**Coal Combustion Waste Impoundment**

**Round 7 - Dam Assessment Report**

*Riverside Generating Station (Site 15)*

*Ash Ponds*

**Figure 5.2.1-1:** Crest of North Ash Pond dike.

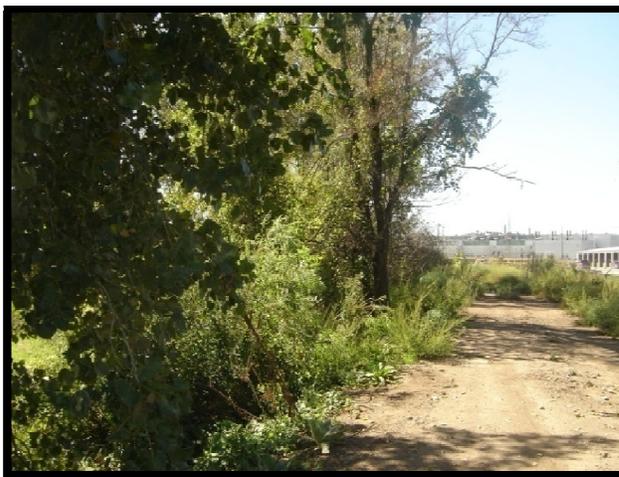
The crest had no signs of any rutting, depressions, tension cracks or other indications of settlement or shear failure, and appeared to be in satisfactory condition. See Figure 5.2.1-1.
